<b>Project:</b>	2023-RFT-058 Lift Station 1 & Lower Iqaluit PT.A2 to LS1 Project		
<b>Addendum No.</b>	4	<b>No. of Pages:</b>	16
<b>Date:</b>	August 14, 2023	<b>Doc. No:</b>	P7201-810372863-118(1.0)

The following change(s) in the Request for Quotation Documents are effective immediately.  
This Addendum forms part of the Contract Documents.

#### DRAWING REVISIONS

TEMPORARY  
EQUALIZATION TANK  
SECTION

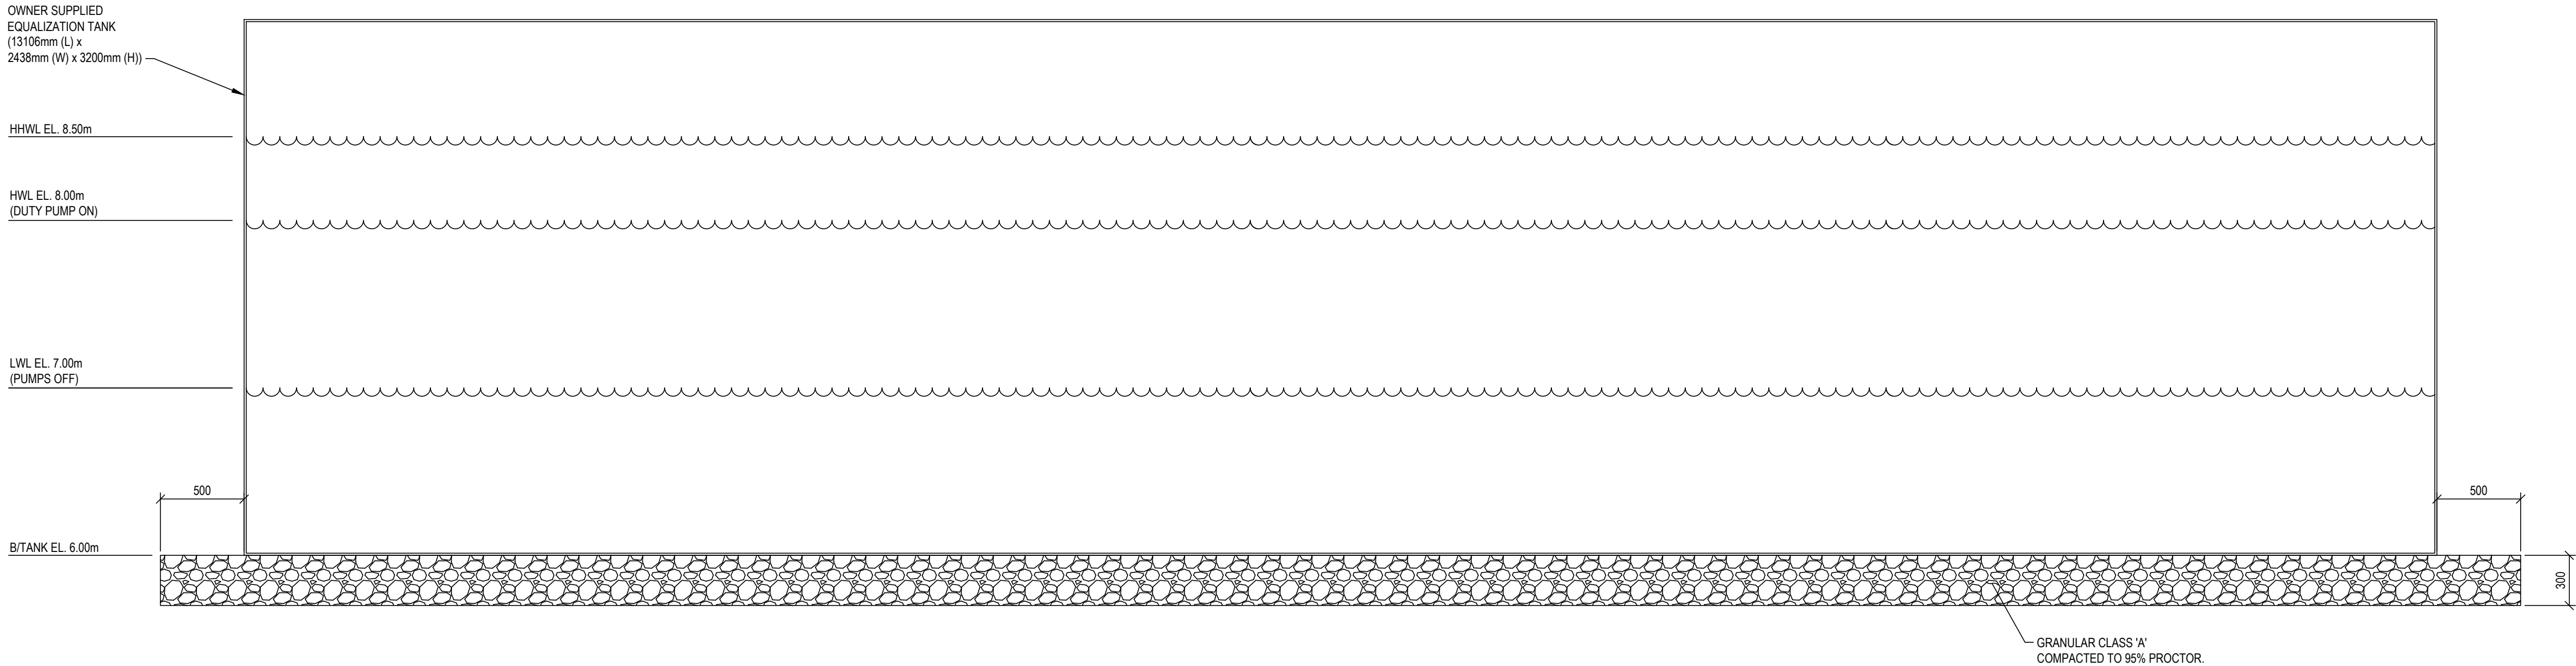
**Q12.** In 2021 the City did a project call the temporary lift station bypass project and the City purchased an equalization tank (frack Tank) and electric drive pumps. Will it be possible to use these items for the present project? if yes can we get the specs for these items?  
Also, can you confirm that the tie-in to existing force main planned to be done in the project in 2021 was done as per design and usable for this RFT?

**A12:** The frac tank is available. Note the following:

- Frac tank only is being supplied, no inlet or outlet piping.
- Contractor is responsible for picking up the tank from a City-specified location.
- Contractor is responsible for returning the tank at a City-specified location.

- Contractor is responsible for any repairs or replacements if any damage is incurred on the tank.
- Bypass design drawings are being provided to show the intended design of the tank and forcemain tie-in. The City is not responsible and will not accommodate any cost changes for any deviations in actual conditions at the time of tank pickup.
